Subject: GE Responses to the Resolution of Issues Related to ABWR DSER
Chapters 1,2,3,5,6,9,10,12,13,14 & 15 (SECY-91-355)

RESPONSE TO OUTSTANDING ISSUES (2) THROUGH (13)

SUMMARY RESPONSE TO OUTSTANDING AND CONFIRMATORY ISSUES OF
ABWR DSER CHAPTERS 1, 2, 3, 5, 6, 8, 10, 12, 13, 14 and 15
SECY-91-355

FIGURE G.2.1.5-R

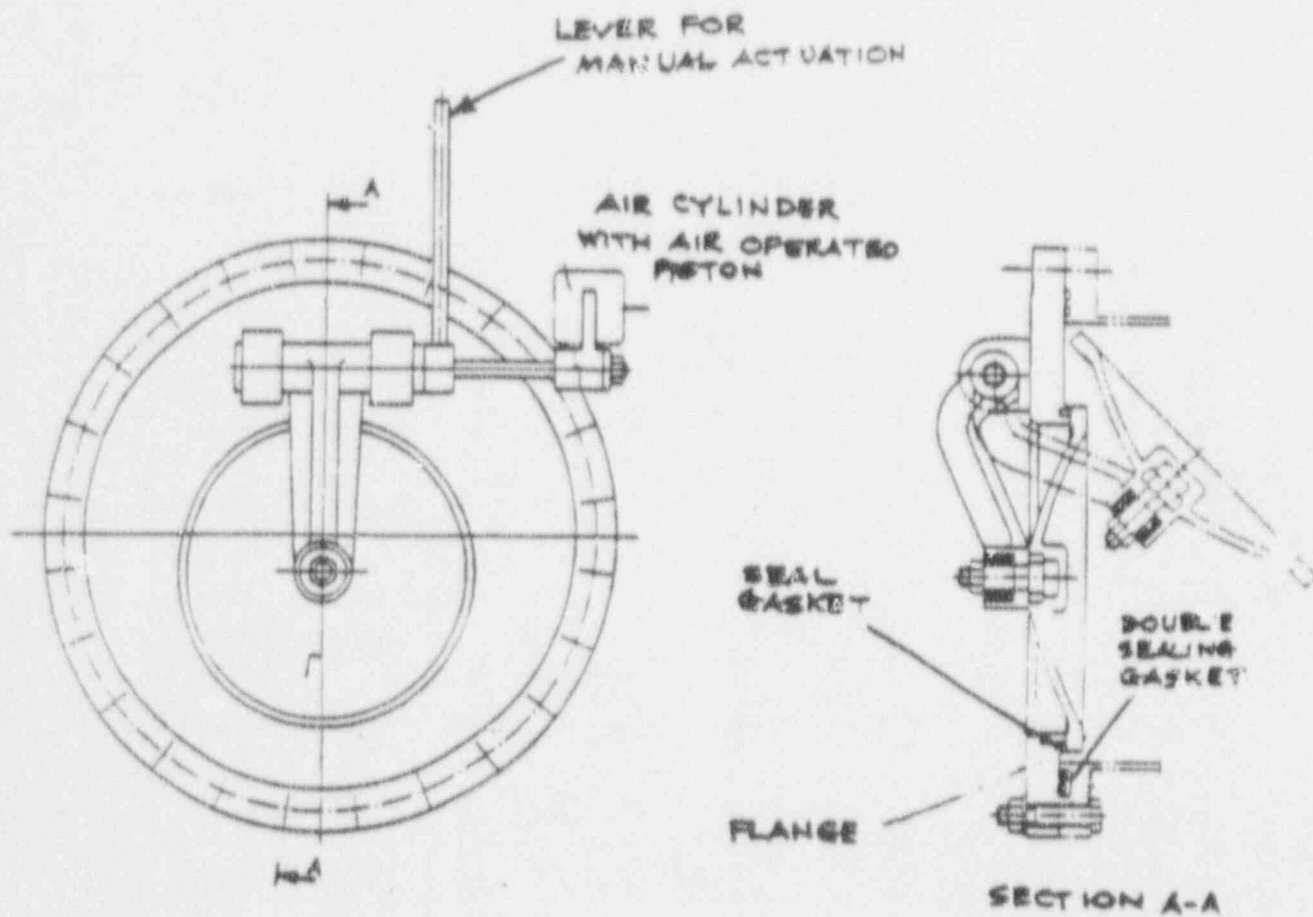
ISSUE (4): Drywell Depressurization (6.2.1.5.1)

WW/DW vacuum breaker (VB) system in ABWR containment design utilizes, in all, eight 20 in vacuum breaker valves, which includes one valve for single failure (valve fail to open) criterion. These valves are intended to be swing check type valves which open passively due to negative differential pressure (WW airspace greater than the DW pressure) across the valve disk, and require no external power to actuate them. VB valves are installed horizontally locating in WW airspace, one valve per penetration (through pedestal wall) opening into L/D. Position locations of these valves, both axially and azimuthally, are shown in Figures 1.2-3C and 1.2-13K in SSAR, Amendment 6. Attached Figure 6.2.1.5.1-a shows a typical swing check type valve.

FIGURE G.2.1.6-a: Comparison of Predicted Vent Steam Mass Fluxes Between ABWR and Full-Scale Tests

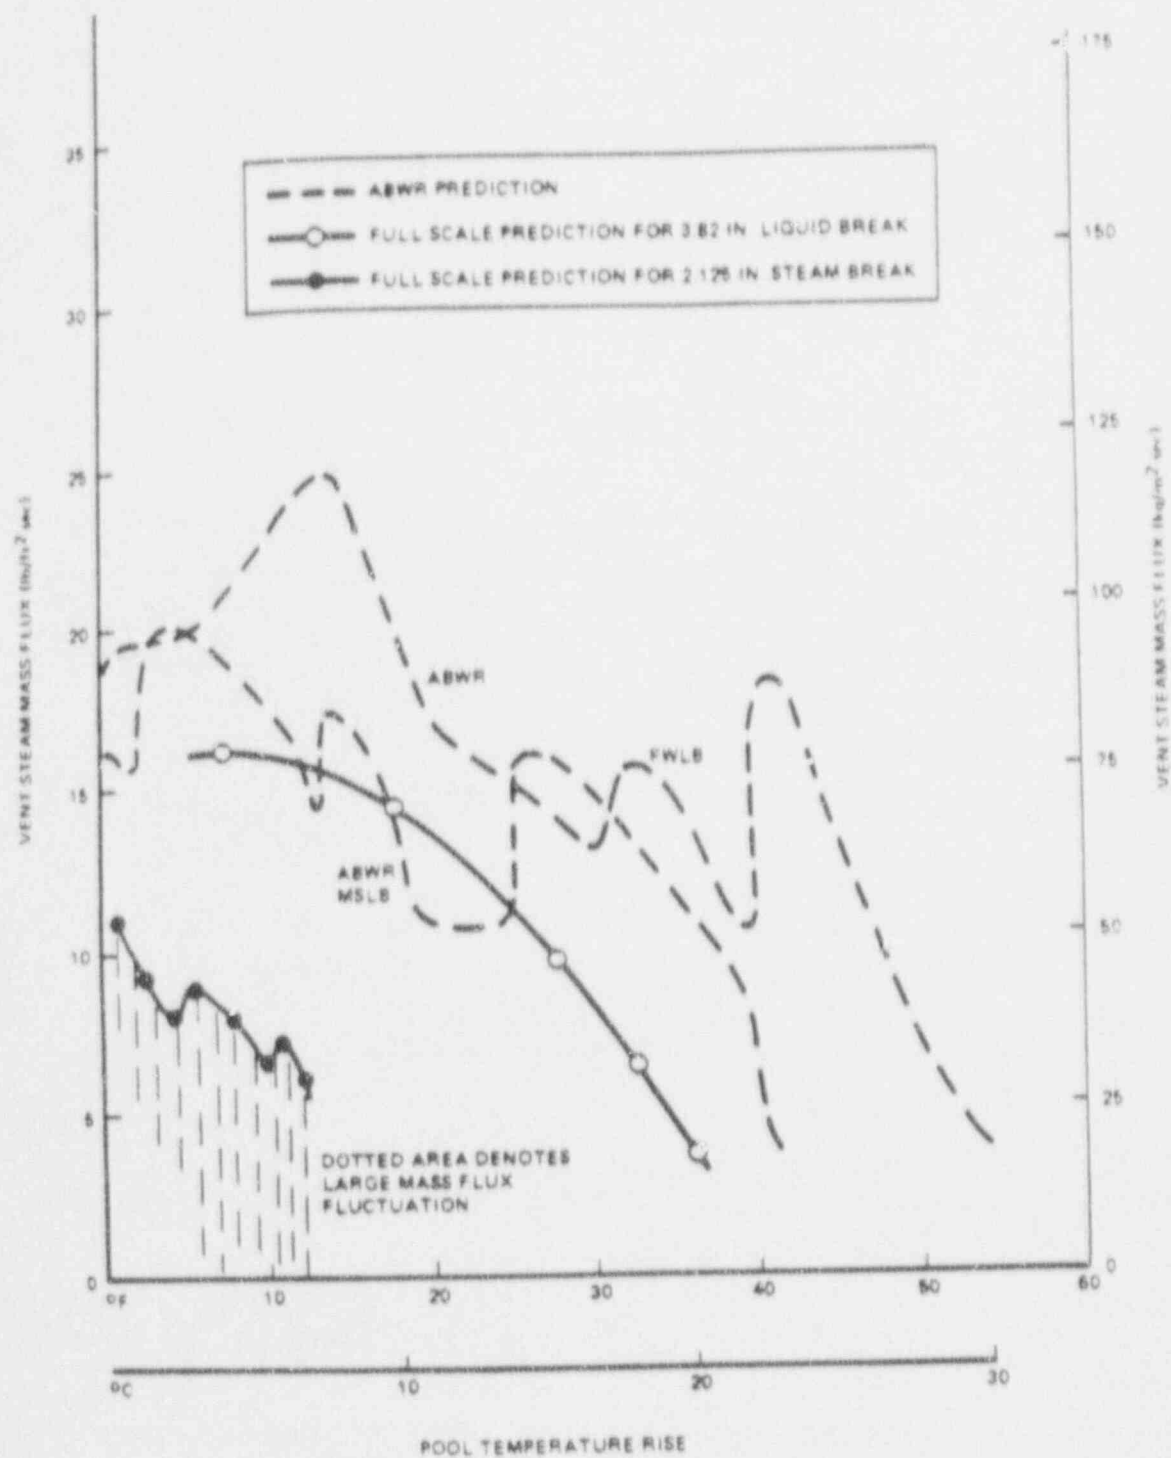
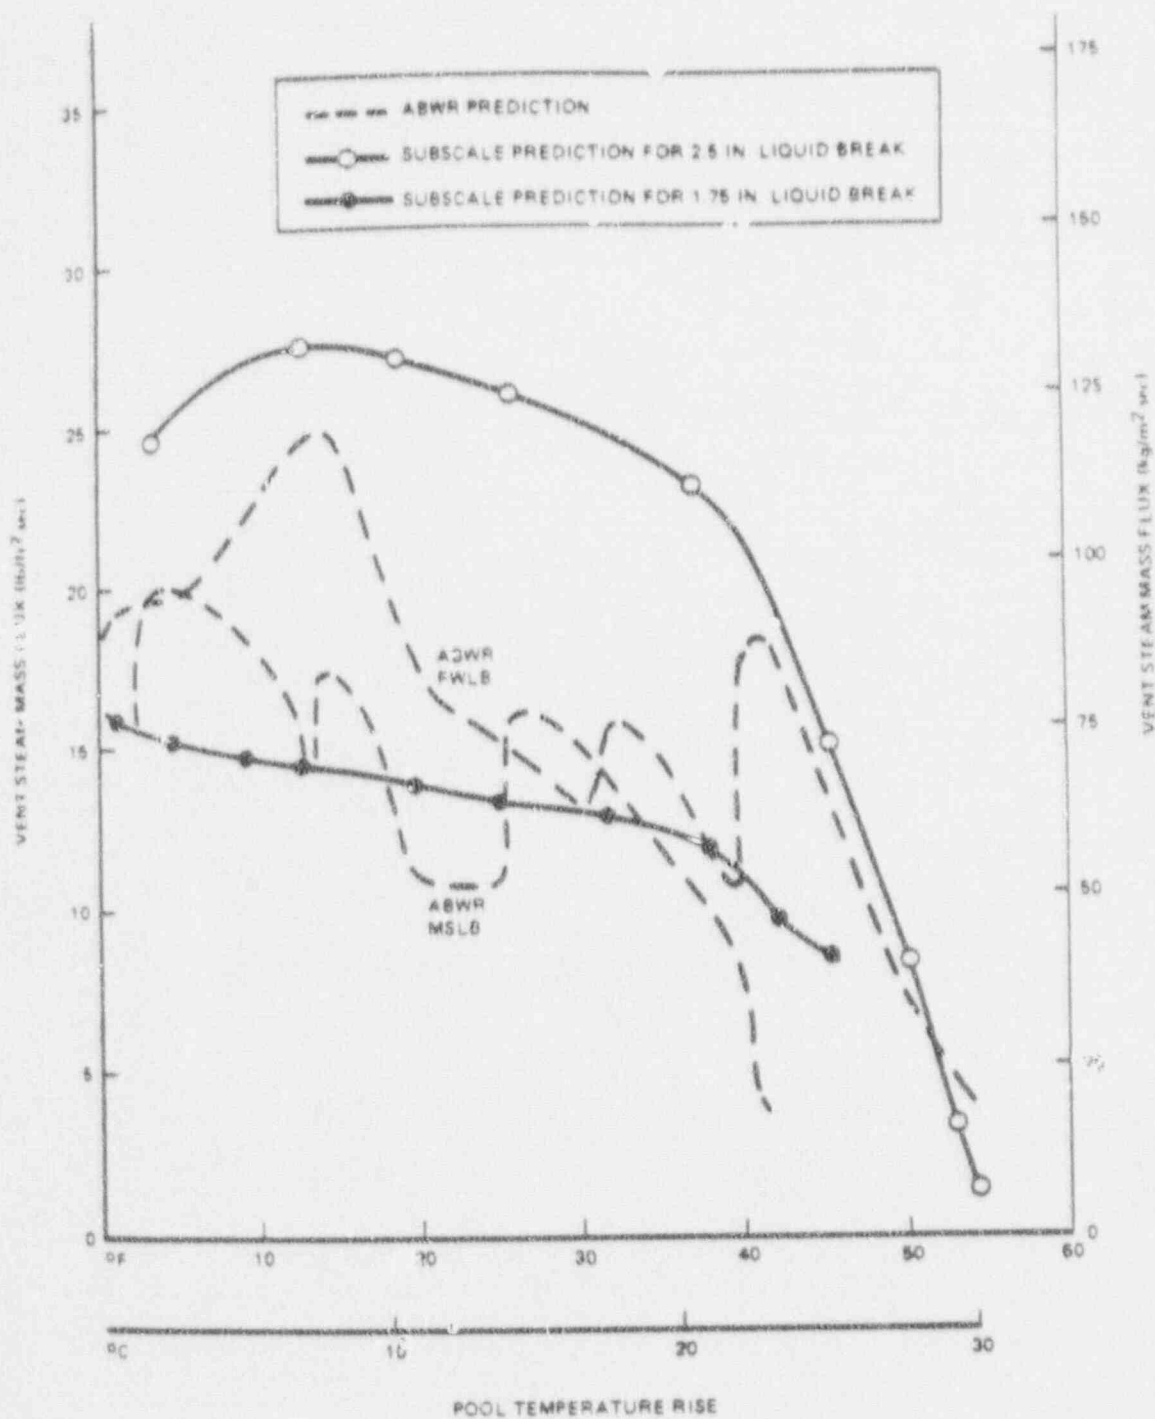
ISSUE (5): Suppression Pool SRV Loading Tests (6.2.1.6)

Attached Figures 6.2.1.6-a and 6.2.1.6-b show a comparison of vent steam mass flux vs pool temperature rise conditions between ABWR plant and ABWR horizontal vent tests.

FIGURE 6.2.1.7-a

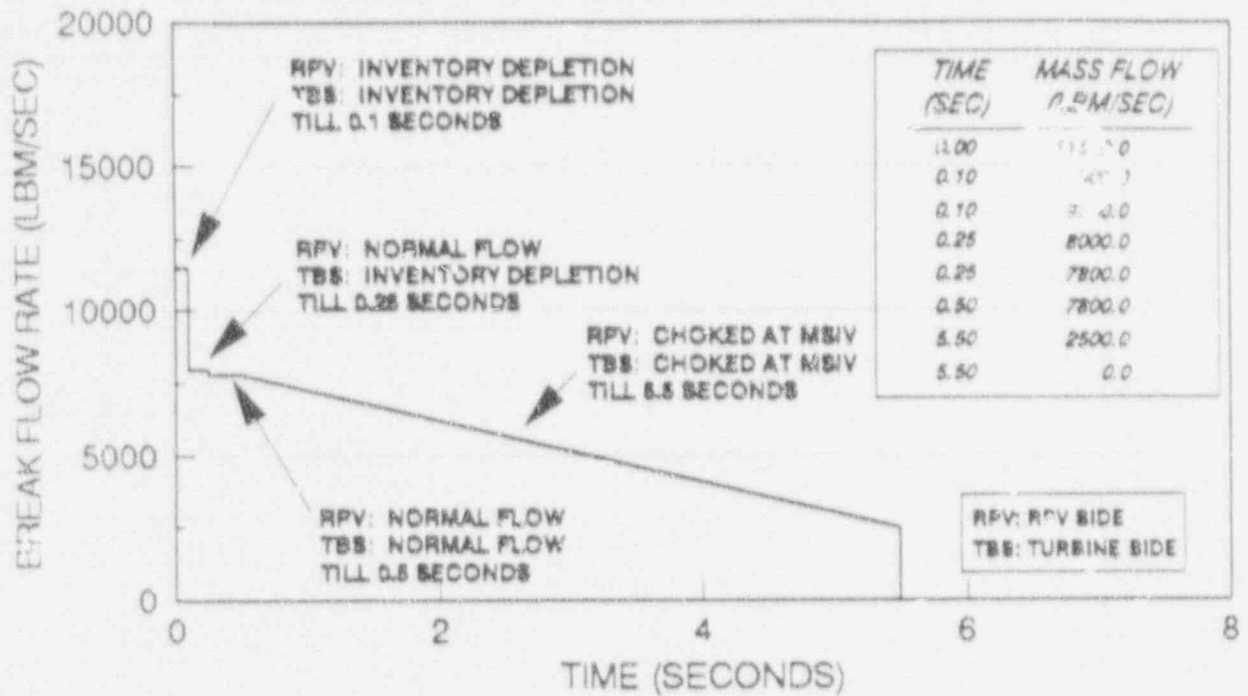
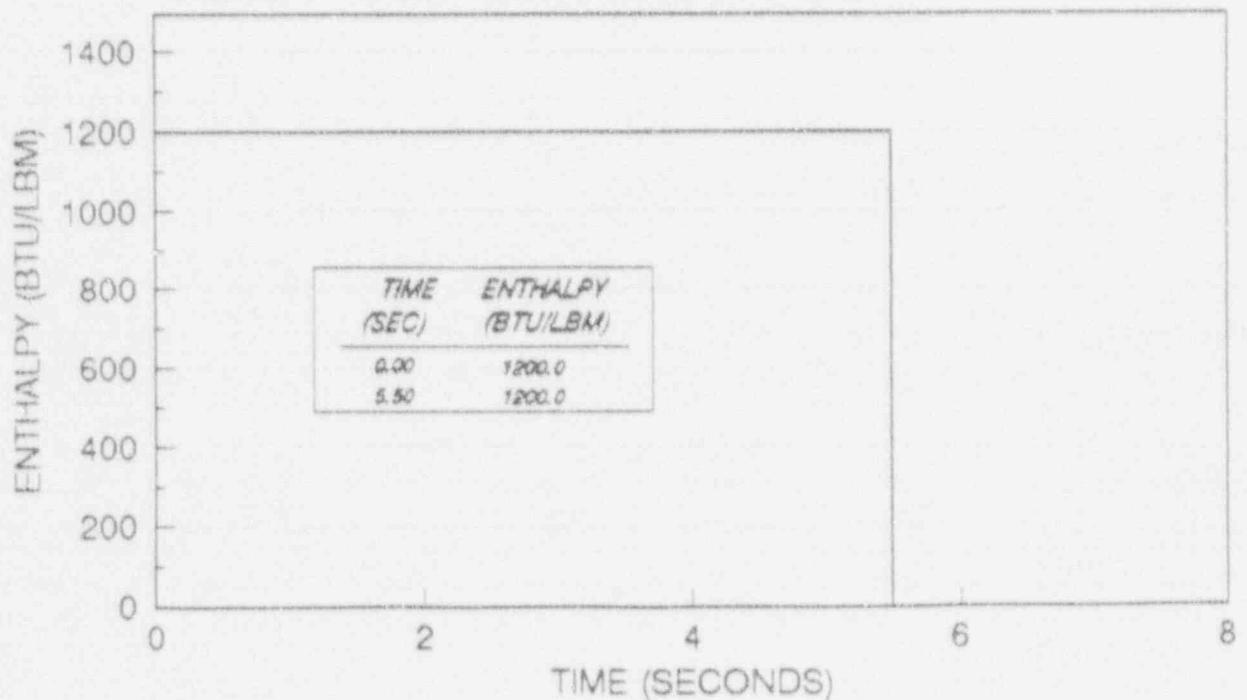
ISSUE (12): Subcompartment Pressure Analysis 6.2.1.7

1. The time dependent mass and energy release rates were determined using critical flow homogeneous equilibrium models, and were ramped to zero over the valve closure time. Typical values used in analyzing a MSL break in steam tunnel are shown in Figure 6.2.1.7-a.
2. The subcompartment pressure analyses were performed using GE engineering computer program SCAM (Subcompartment Analysis Method).
3. No specific nodalization sensitivity studies were performed.
4. Subcompartment initial thermodynamic conditions were those corresponding to plant normal operating conditions, as defined in SSAR, Appendix I.

FIGURE 9.5-6

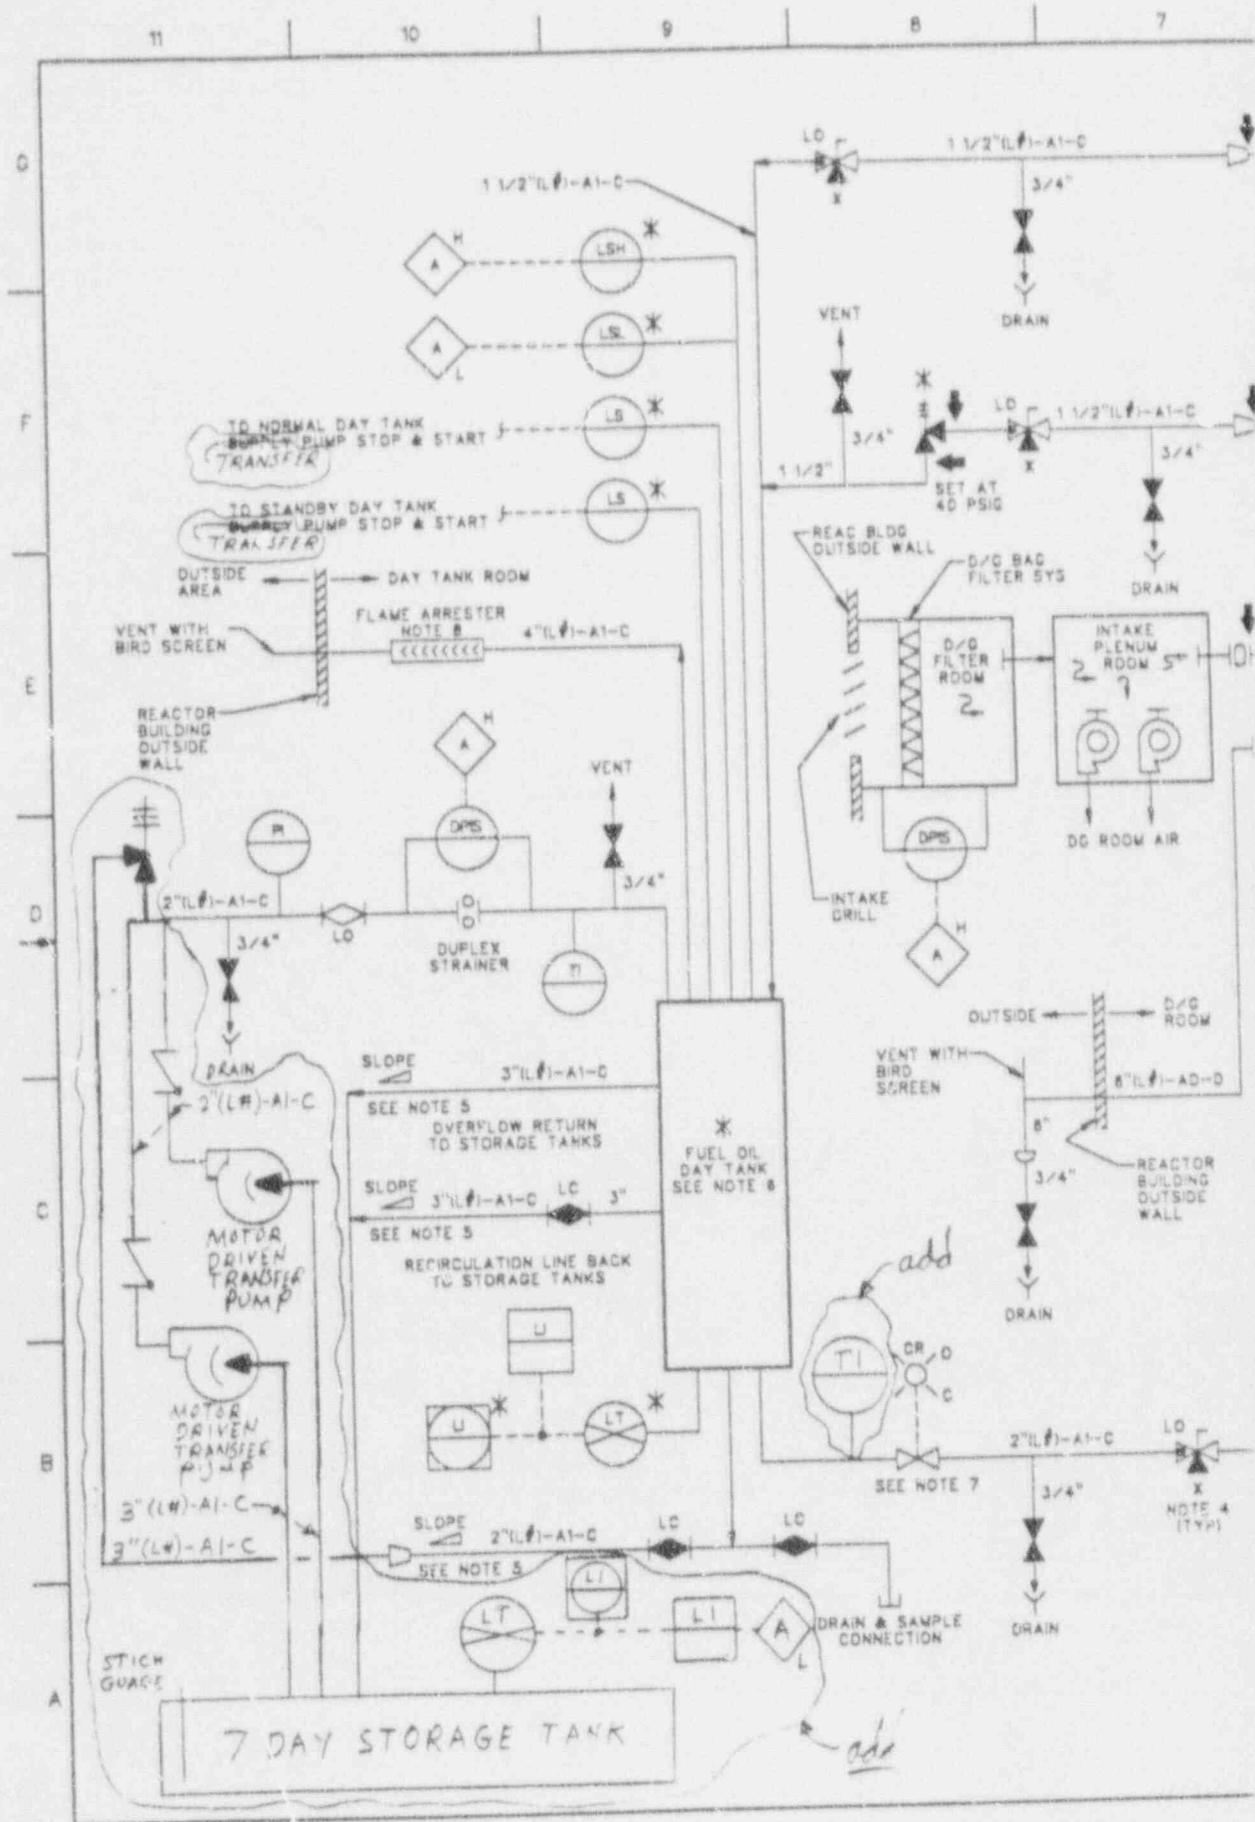
83 Figure 9.5-6 discrepancies (9.5.4.2)

81	Interface requirement for DG fuel oil transfer pump motive power (9.5.4.2)	There are two transfer pumps provided with each diesel generator unit. These have been added to the attached Figure 9.5-6 (page 9.5-18) in response to Issue 83. The pumps are motor-driven.

Figure 9.5-6 (page 9.5-18 attached) has been modified to show the 7 day storage tank, and associated instrumentation, pumps, valves and piping.

A temperature indicator has been added to discharge line of the fuel oil tank in Figure 9.5-6 (page 9.5-18 attached).
